SANBROOK ESTATES SUBDIVISION, UNIT TWO

APPLICATION NUMBER 19 DATE November 15, 2007

DETAIL SITE PLAN

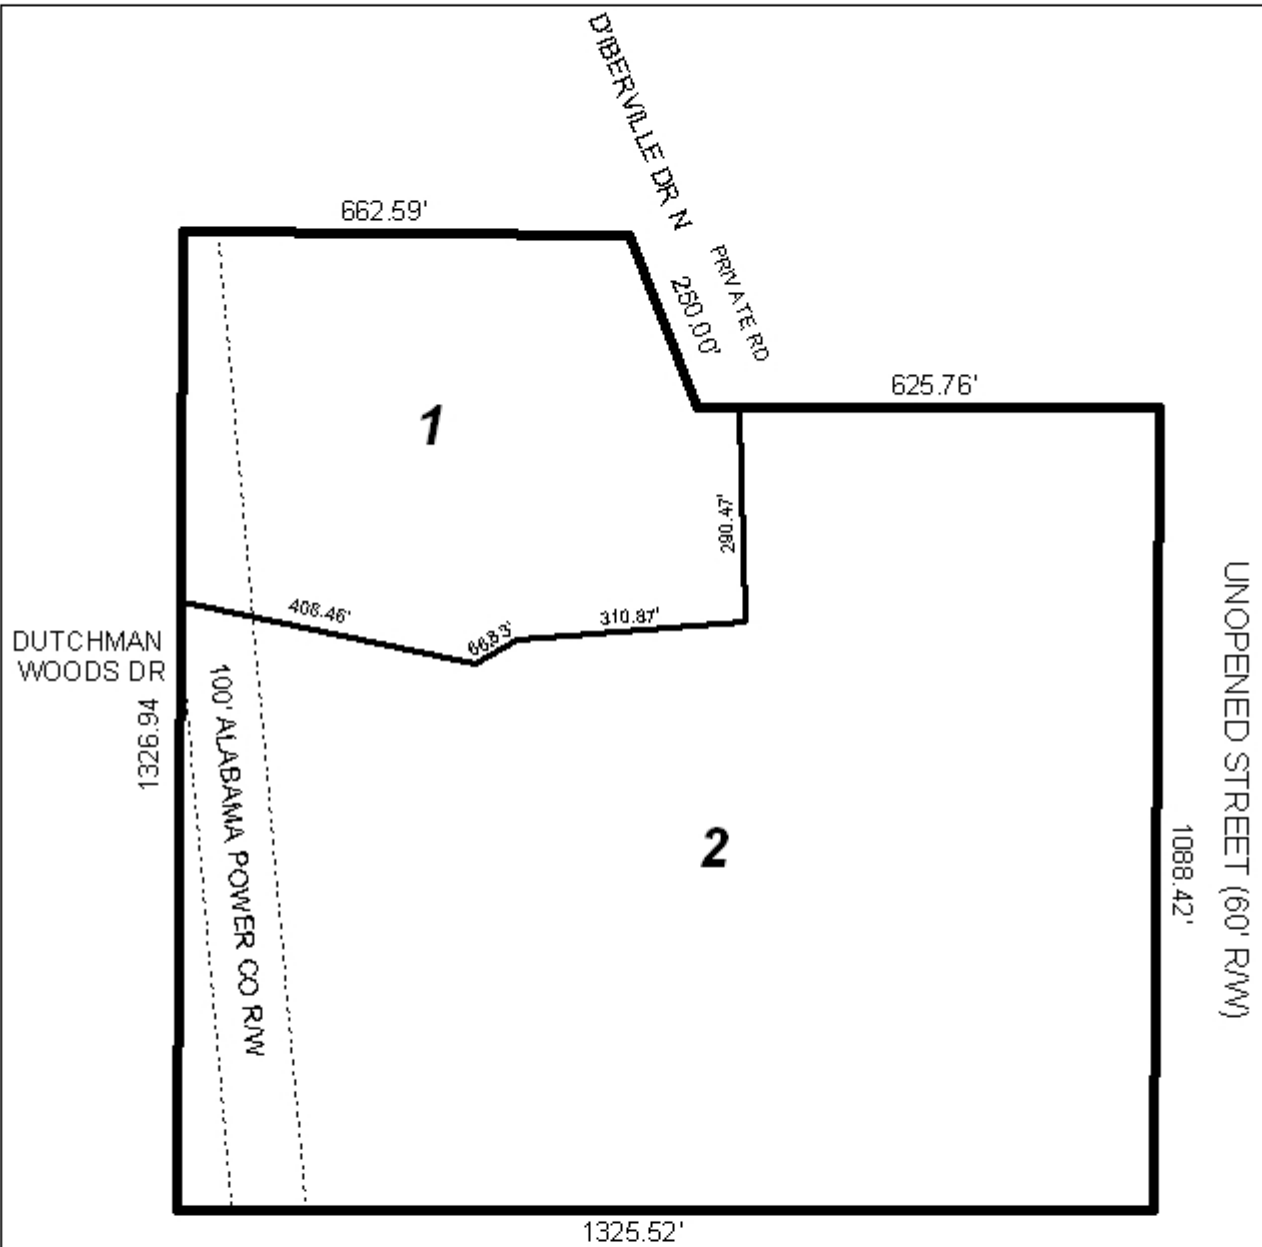
Lot 2 would be at the East terminus of Dutchman Woods Drive, which has adequate 50' right-of-way, and would extend to the West side of an unopened, unnamed public right-of-way 60' in width. No minimum building setback line is indicated on the plat. Since Lot 2 has a 100' Alabama Power Company easement right-of-way immediately inside the property's West boundary, a 25' minimum building setback line along the West boundary would be a moot point; therefore, the building setback line should be placed along the East boundary of the power company easement. On the East side of Lot 2, a 25' minimum building setback line should be indicated along the unopened, unnamed public right-of-way. Lot 2 should also be denied access to this right-of-way until it is constructed to County standards.

During the staff review of this application, documentation was submitted indicating the vacation of a portion of the unopened, unnamed public right-of-way along the East side of the subject property, beginning at a point even with the North right-of-way line of Nugget Drive, and extending to the North 300'. The plat should be revised to show this vacation.

Lot 1 would be along the West and South terminus of a private street known as Private Road 074 which is located beyond the South terminus of D'Iberville Drive North, a public right-of-way of adequate 50' width. In 1993, a two-lot subdivision, Sanbrook Estates, Resubdivision of Unit 1, was approved, with one lot situated on the East side of Private Road 074, directly across from proposed Lot 1 of this subdivision. A condition of approval of that subdivision was the paving of the private street at the time Lot 1 of that subdivision was developed. That lot has since been developed, but the private drive does not appear to have been paved, as conditioned. To correct such, this subdivision, or at least Lot 1, should not be recorded until the private drive has been paved to County standards for such.

Each lot was labeled on the plat with its size in acreage; the final plat should have each lot labeled with its size in acreage, or a table should be provided furnishing the same information.

As indicated on the vicinity map, the site contains a creek and two lakes, and as such the area may be considered environmentally sensitive; therefore, the approval of any necessary federal, state, and local agencies would be required, and a note stating such should be placed on the final plat.

- 1) placement of the building setback line for the West side of Lot 2 along the East edge of the Alabama Power Company right-of-way easement;
- 2) placement of the 25' minimum building setback line on the East side of Lot 2 along the unopened, unnamed public right-of-way;

- 3) placement of a note on the final plat stating that Lot 2 is denied access to the unopened, unnamed right-of-way along the East side until it is constructed to County standards;

- 4) revision of the plat to indicate the vacated portion of the unopened, unnamed public right-of-way along the East side of the property, North of the West terminus of Nugget Drive;

- 5) placement of a note on the final plat stating that Lot 1 is not to be recorded until Private Road 074 has been constructed to County standards for such;

- 6) labeling of each lot with its size in acres, or the provision of a table furnishing the same information;
- 7) placement of a note on the final plat stating that the approval of all applicable federal, state and local agencies is required prior to the issuance of any permits or land disturbance activities;
